Product Change Notification

106062 - 00

Change Notification #:	**106062 - 00**
Change Title:	**Intel (R) NetStructure (R) MPCHC0001 14U Chassis and MPFIL0001 Filter Tray Spare Part, PCN 106062-00, Product Material, RoHS Compliant version filter tray cable assembly**
Date of Publication:	**March 28, 2006**

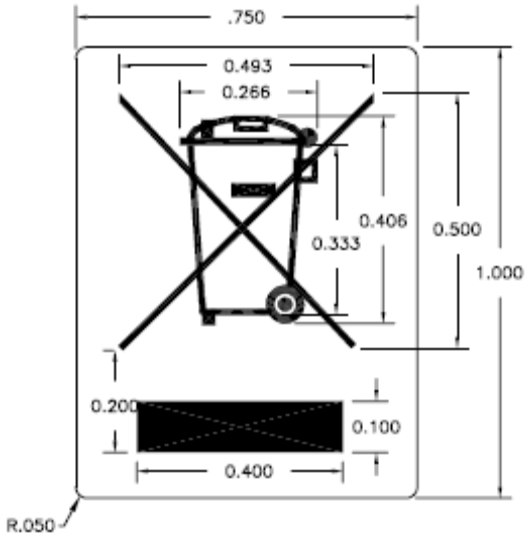
Adding WEEE label to chassis.
